# SUBJECT: N0380/16 - 44 BYNYA ROAD, PALM BEACH NSW 2108 Alterations and additions to an existing dwelling house

SUMMARY OF RECOMMENDATION: CONSENT WITH CONDITIONS

REPORT PREPARED BY: Christopher Nguyen

## Overshadowing impact on 42 Bynya Road

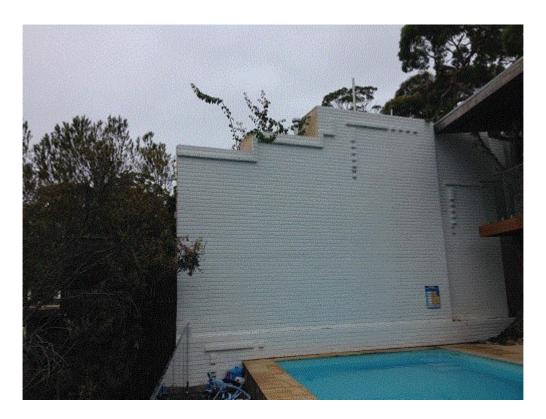
The objector located at 42 Bynya Road raised concerns regarding the first floor addition and its overshadowing impact on their dwelling. A site inspection on 19/01/2017 was conducted at 42 Bynya Road to assess the overshadowing impact. The site inspection found the overshadowing impact from the first floor addition towards 42 Bynya Road is not unreasonable. The rooms affected by overshadowing are those closest to the northern boundary, particularly the bedroom. This bedroom contains a high window which obtains sunlight and an open view of daylight. This bedroom and its adjoining entry room most likely will be overshadowed during the afternoon and early evening, however this portion of the dwelling cannot be considered principal living areas. The dwelling contains living room located centrally within the dwelling which are considered the principal living areas of the dwelling. This space is unaffected by overshadowing from the proposed dwelling at 44 Bynya Road and therefore the overshadowing is considered to have a minimal impact.
